Re: Florida Power & Light Company  
Proposed Turkey Point Units 6 and 7  
Docket Nos. 52-040 and 52-041  
Response to NRC Request for Additional Information Letter 120316  
(RAI 6347 Rev. 1) Related to ESRP Section 9.3 – US Army Corps of Engineers

Proposed Turkey Point Units 6 and 7  
Docket Nos. 52-040 and 52-041  
FPL Response to NRC RAI No. EIS USACE-2 (RAI 6347 Rev. 1)  
L-2012-188 Attachment Page 1 of 8

**NRC RAI Number: EIS USACE-2 (RAI 6347 Rev. 1)**

#### **Alternative Analysis Flow Chart And Practicability Evaluation Matrix**

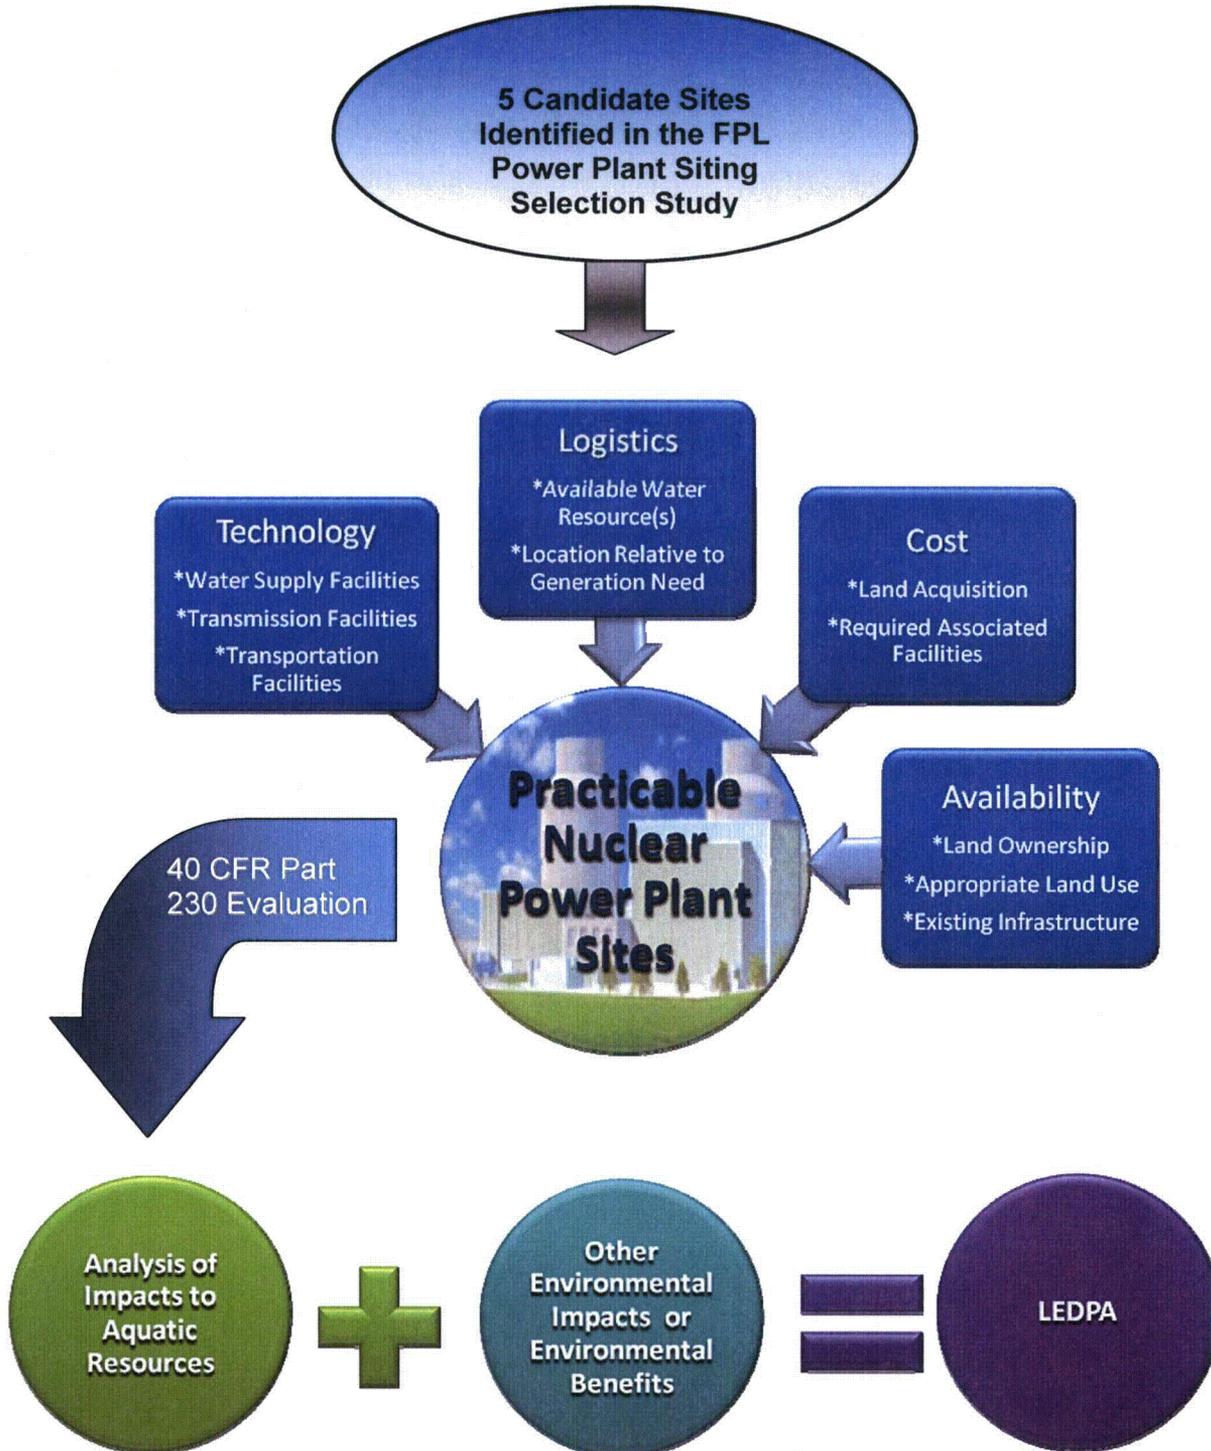
The Corps requested a matrix/flow chart of the last five sites be included in a revised submittal.

The alternative analysis flow chart and practicability evaluation matrix for the last five sites is enclosed.
